**ADDENDUM NO. 02  
TO THE CONSTRUCTION DOCUMENTS BID PACKAGE**

**Client:** Arrowhead Regional Medical Center  
**Project:** Oncology-Ambulatory Clinic  
**SHA Project No.:** 18242.100  
**Date:** September 12, 2019

**A4** PARTIAL MECHANICAL FLOOR PLAN - AREA 'A'

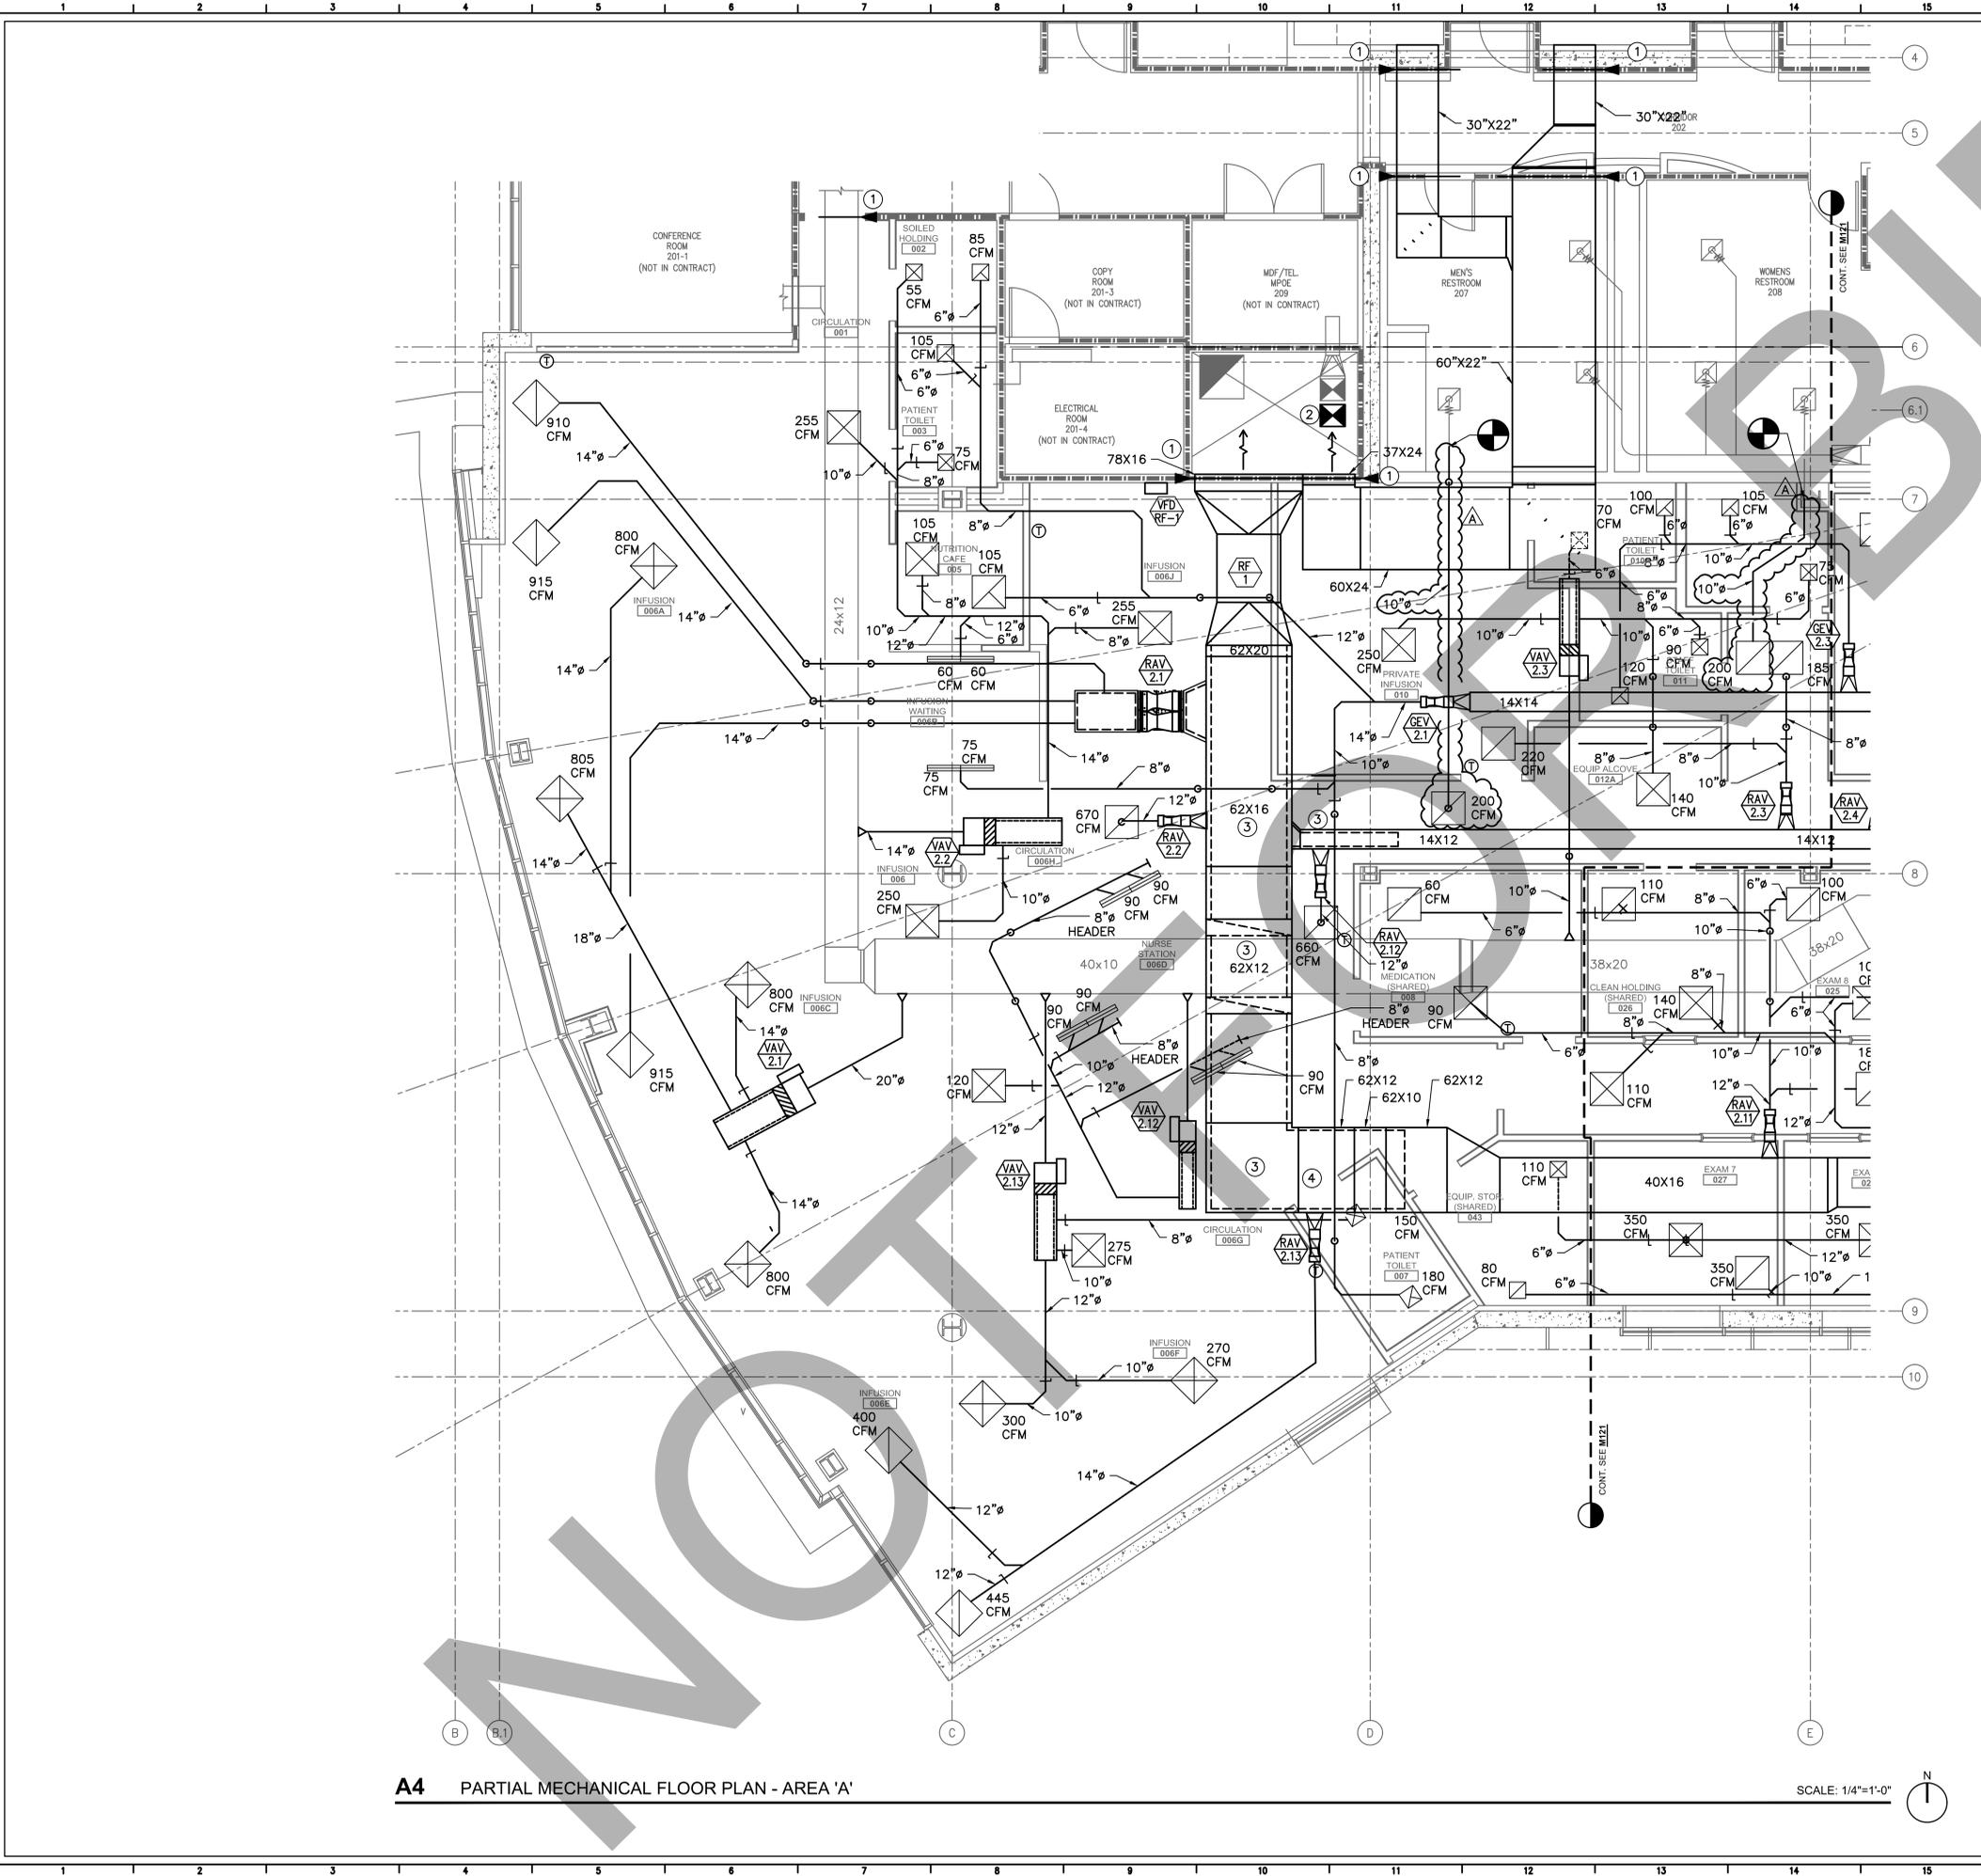
- A605** Revised detail number.
- M111** Revised demolition scope in the existing public restrooms.
- M122** Revised ductwork.
- M125** Added note to sheet regarding patching exterior finishes.  
Added General Note #4 referencing framing details.

002.5	Sheet A111 DM15 shows removal of ceiling in restrooms 207 & 208. Sheet M122 shows these areas as "not in contract". Please confirm these areas are in the scope of work.	Keynote DM15 indicates to DEMOLISH EXISTING CEILING AS REQUIRED BY NEW MECHANICAL WORK ONLY. Coordinate with scope shown on Mechanical drawings. M122 should NOT indicate "NOT IN SCOPE". See revised Mechanical sheets attached.

002.6	Sheet M112 shows new CFSD's crossing corridor 202 into another space not shown on the plans. Please provide additional information about this area. Additionally M122 shows this area as "not in contract" Please confirm this area is in the scope of work.	Corridor M122 is in contract, see attached revised Mechanical sheets and Architectural Demolition Plan. The ducts that cross corridor 202 are open to the existing return air plenum. The area above OSHPD spaces are not allowed to convey return air per mechanical code. This provides a way to get return air from the rest of the floor back to the main return air shaft that stubs out above the suite.

FLOOR PATTERN AND ACCENT WALL FINISH PLAN  
 SCALE: 3/16" = 1'-0" 1

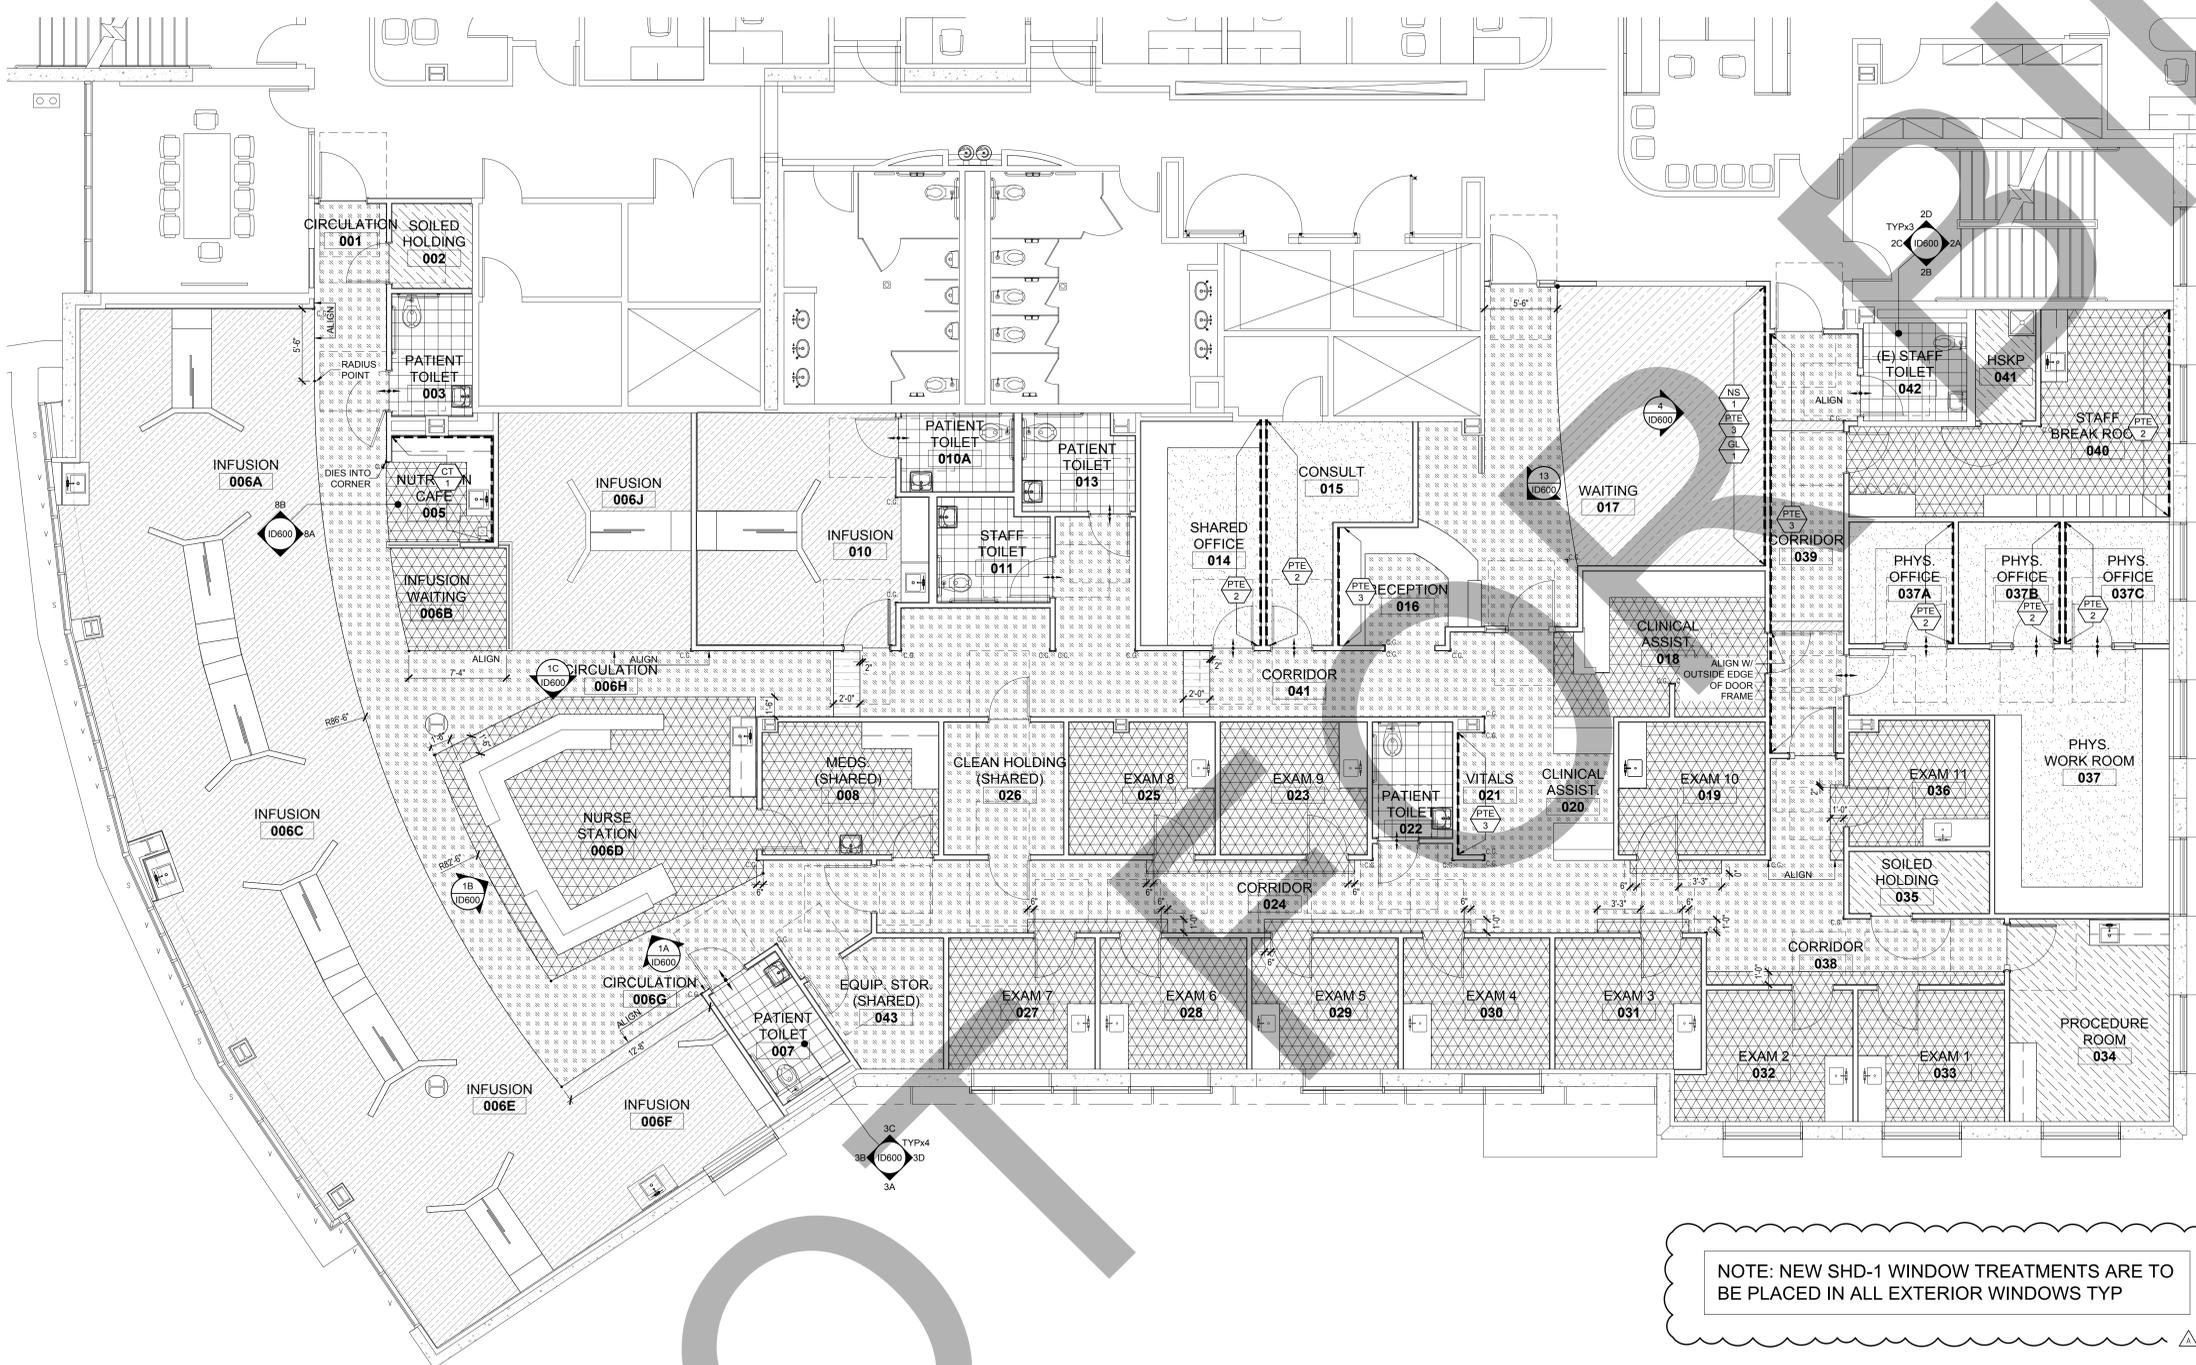
**ID300 Added Note to plan regarding Window Treatments.**

005.1	Please advise who is responsible for Window Treatment. Specification section 09 00 00 calls for Window Treatment SHD-1 to match building standards, but there are no call outs on the drawings.	Window Treatments are to be contractor furnished/contractor installed. See revised Interior Design drawings and Specification Sections attached.

ELEVATION - TYPICAL STAFF TOILET  
 SCALE: 3/8" = 1'-0"

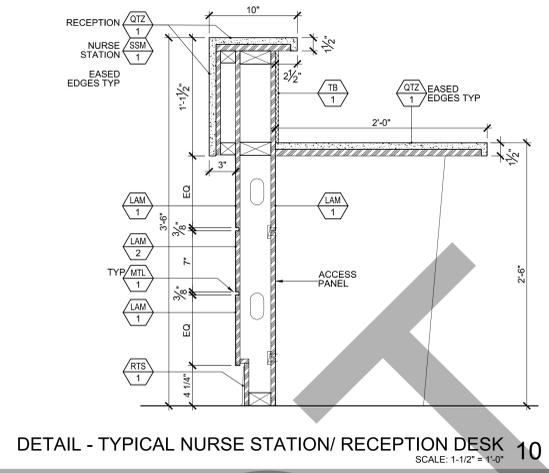
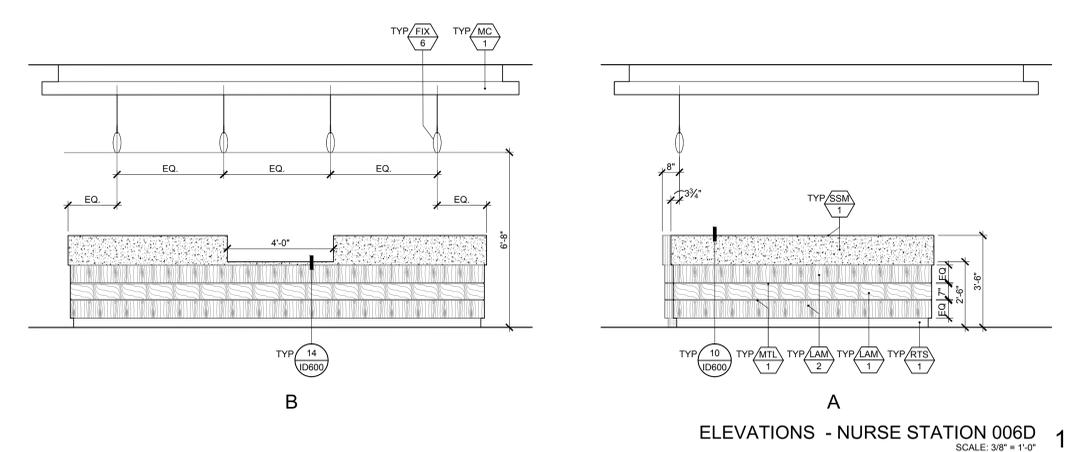
**ID600 Typical Toilet Room Interior Elevations revised to match Architectural drawings.**

003.3	Interior elevations A3, E7 & J7/A204 show wall hung sinks at Patient and Staff Toilet Rooms. Elevations 2 & 3/ID600 & Finish Schedule on ID700 show solid surface countertop with undermount sink at these locations. Please clarify if these sinks are wall or counter mounted.	The sinks shown on the Architectural interior elevations and referenced in this RFI are to be wall hung per the architectural drawings. The Interior Design drawings have been revised, see attached revised ID drawings.
